D5.4 R21-07 Xerox® AltaLink® Product Enhancement Document for Version 113.xxx.021.20610

Description of new features and enhancements to the products specified below.

Release Date: August 12, 2021

2. Enhanced Preview Capabilities

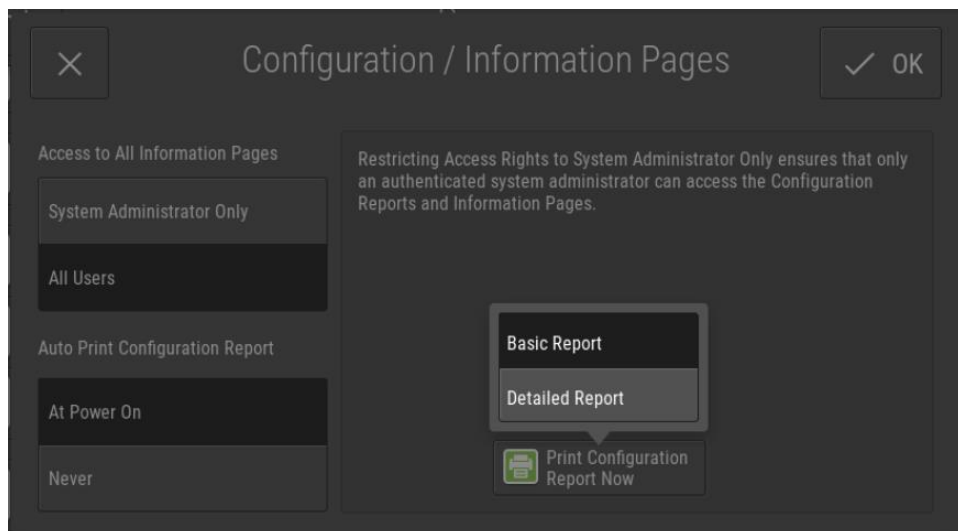
Introduces new preview capabilities to the native preview feature for Scan To and Scan to Email. Preview now supports the ability to delete images, re-order images and to change scan settings between scan segments.

The Scan API has been updated to allow EIP apps to take advantage of the native preview feature.

4. Detailed Configuration Report

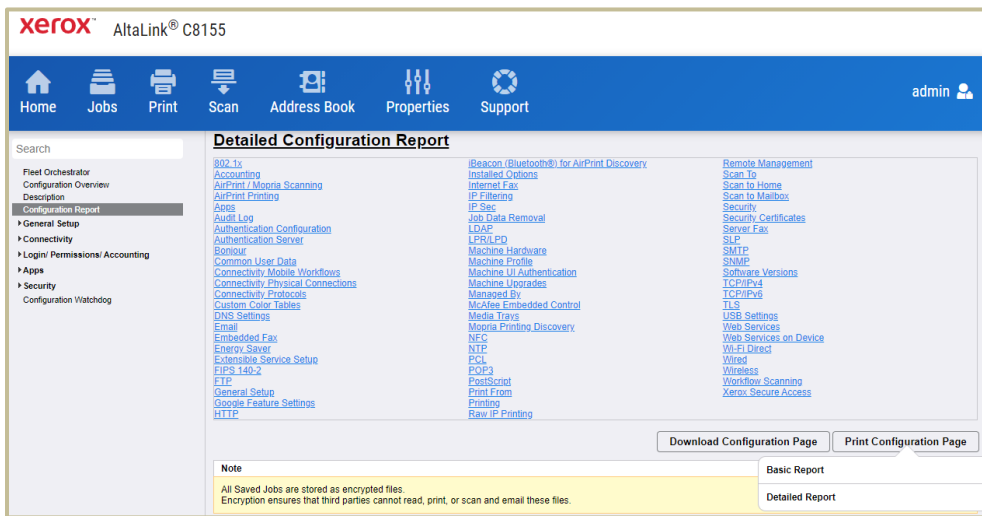
Introduces new Configuration Report options of Basic and Detailed. Both versions of the report can be printed by the Admin or guest user if access is configured. The Configuration Reports are accessible through the EWS and Local UI.

From the LUI, the Admin can configure the device to control access to the Basic and Detailed configuration reports. (Device App -> Tools -> Configuration / Information Pages). Printing of the reports is also available by selecting "Print Configuration Report Now" & selecting the Basic or Detailed Report.

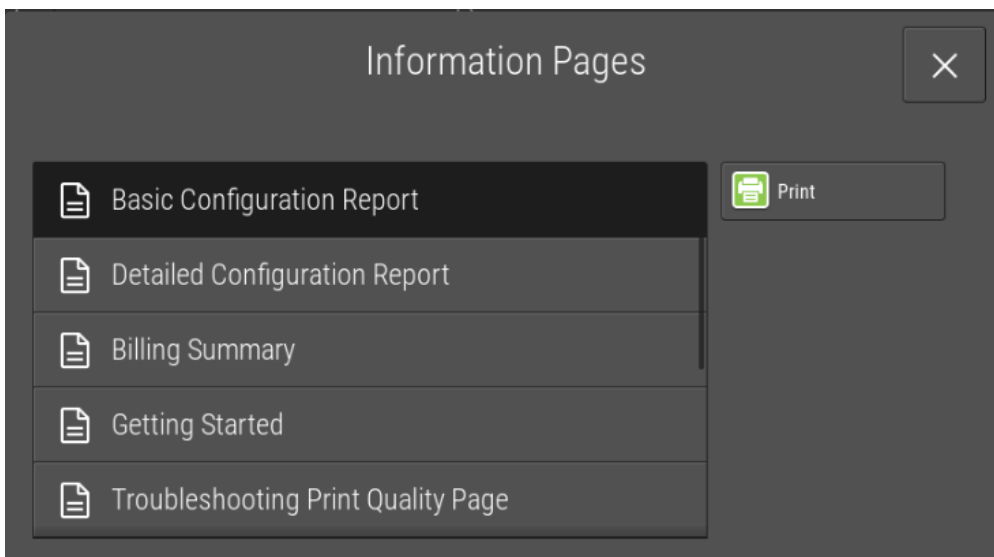
Printing of the configuration reports from EWS:
Properties -> Configuration Report -> Print Configuration Page -> Select the Basic or Detailed Report
